Technical Note

Project title	Victoria North
Job number	282022
File reference	4-05-11
cc	
Prepared by	Del Harrison
Date	18 March 2024
Subject	Addendum to Remediation Implementation Plan (RIP): Phase 1 re-use criteria

Figure 1 Victoria North Phase 1 boundary

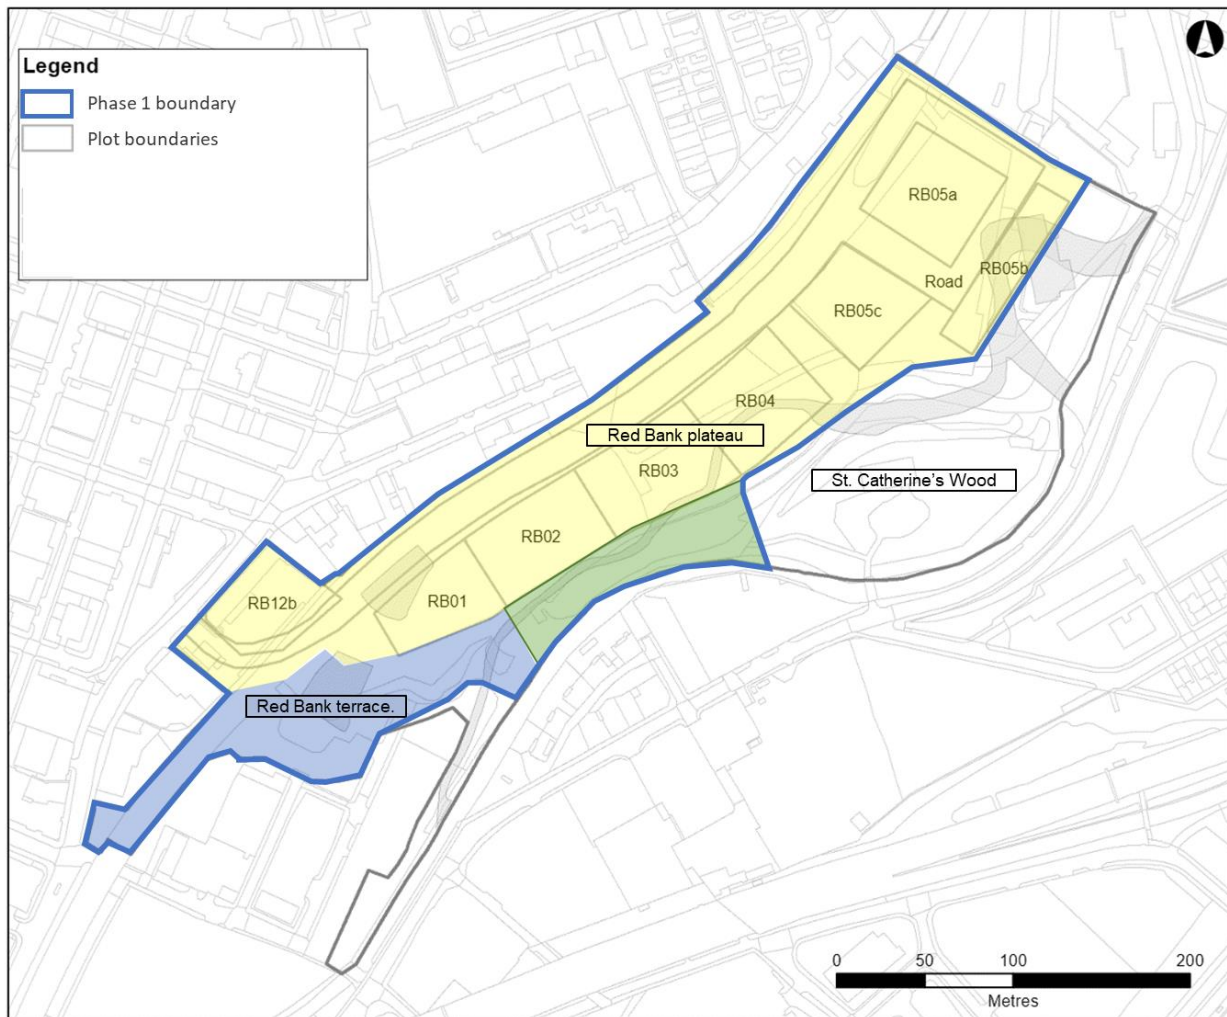
The remedial targets developed in the DQRA were transferred into the Remediation Strategy² and Remediation Implementation Plan (RIP)³ for Phase 1 of the works. The Phase 1 site boundary is shown in **Figure 1** below and comprises the areas of Victoria North known as Red Bank Plateau and Red Bank Terrace.
